RE: Roof Replacement at Lago Vista Middle School
 Lago Vista Independent School District
 RFCSP NO. 20210301
 EE Project No. 122-001

ADDENDUM NO. 1

1 GUTTER DETAIL
 Scale: 3"=1'-0"

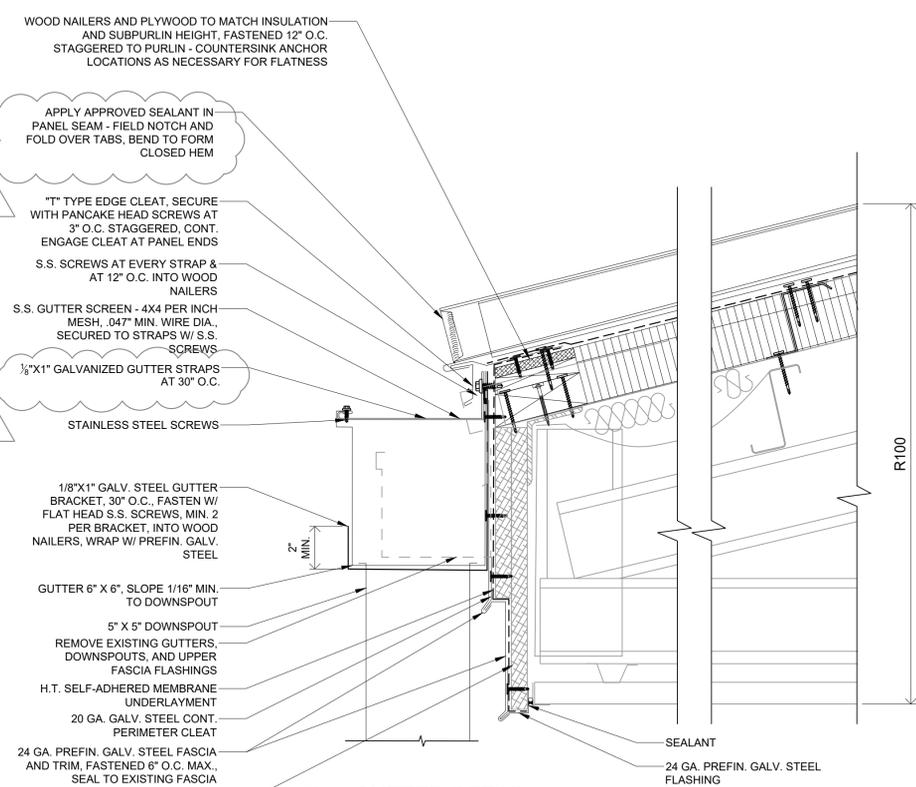
R2.05	<p><i>Replace with the attached REVISED “R2.05”</i></p> <ul style="list-style-type: none"> - Clarified Alt. Bid wall panel work at existing louvers
R3.00	<p><i>Replace with the attached REVISED “R3.00”</i></p> <ul style="list-style-type: none"> - Detail 1, Gutter: Minor text clarifications, deleted requirement to coat gutter straps - Detail 2, Rake Detail: revised to reflect field conditions and match fascia replacement indicated at gutter detail - Detail 3, Rake at High Eave: revised notes to match components drawn - Detail 4, Ridge: revised 24” width to 18” for added layer of underlayment to match ridge details at other sheets
R3.01	<p><i>Replace with the attached REVISED “R3.01”</i></p> <ul style="list-style-type: none"> - Detail 1, Gutter: Minor text clarifications, deleted requirement to coat gutter straps - Detail 4, Ridge: clarified note for added layer of underlayment
R3.03	<p><i>Replace with the attached REVISED “R3.03”</i></p> <ul style="list-style-type: none"> - Detail 1, Gutter: Minor text clarifications, deleted requirement to coat gutter straps - Detail 4, Ridge: clarified note for added layer of underlayment - Detail 5, Alt. Bid – Rake to Wall Detail: revised trim at new wall panels - Detail 6, Alt. Bid – New Panels at Existing: revised termination of underlayment at trim to seal edge prior to trim installation
